ARLINGTON 425 – PC#: 19-001
PETITIONER RESPONSES TO ROUND 2 COMMENTS
MARCH 15, 2019

RESPONSES TO FIRE SAFETY DIVISION COMMENTS

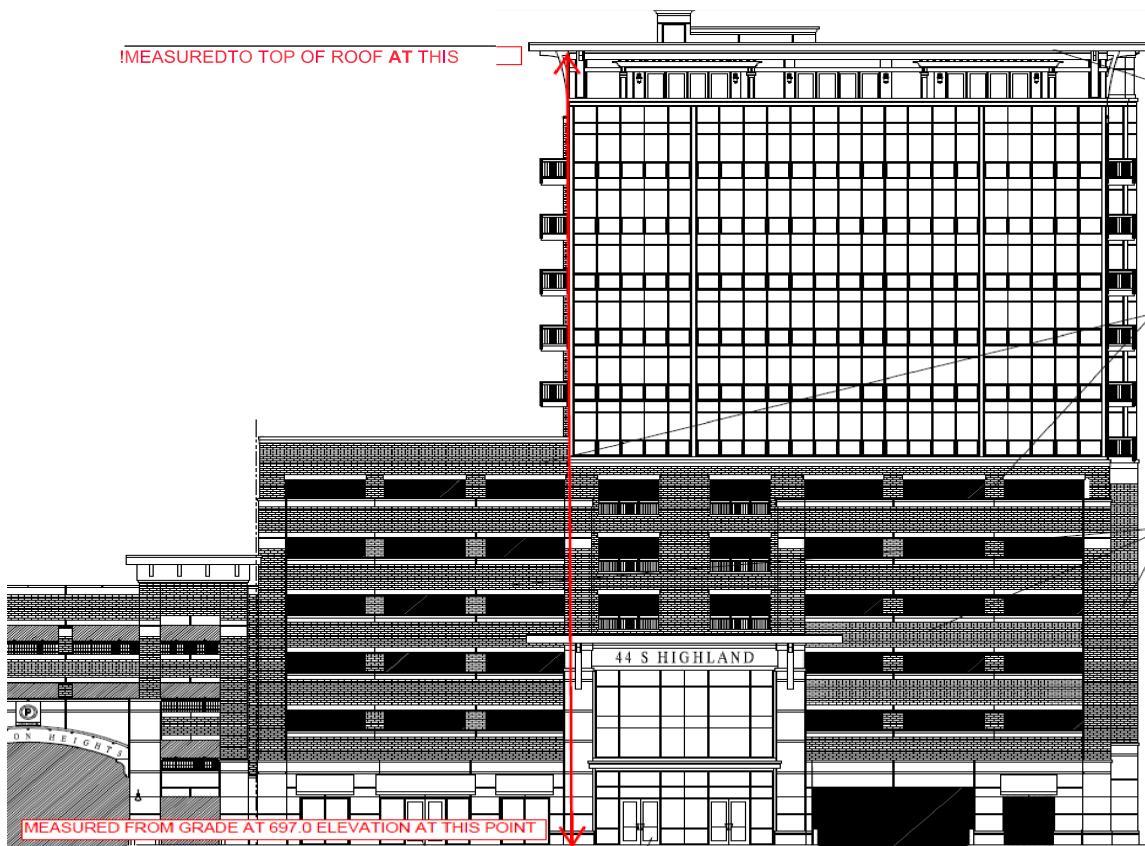
83. The response to Comment #32 is noted. Since no preliminary analysis has been provided, a condition of approval will be recommended that prohibits all construction activities from damaging the Vail Avenue garage. A full structural analysis and soil borings will be required at time of building permit. The Village reserves the right to review any proposed modifications to the Vail Avenue garage and the ability to require certain upgrades to the garage as necessary to facilitate the proposed development (e.g. additional interior lighting, re-routing of electrical lines, etc.). Costs of any garage modifications, insurance, and bonds shall be the developers responsibility.

Response: Duly noted. A site staging and logistics plan has been provided. Retaining the structural integrity of the Vail Avenue garage is of paramount importance. No damage will occur to the Vail Avenue garage during construction of the Highland

Avenue garage, but modifications to non-bearing wall panels will be required at the loading dock area. These will be designed by a structural engineer and shall be subject to the Village approval.
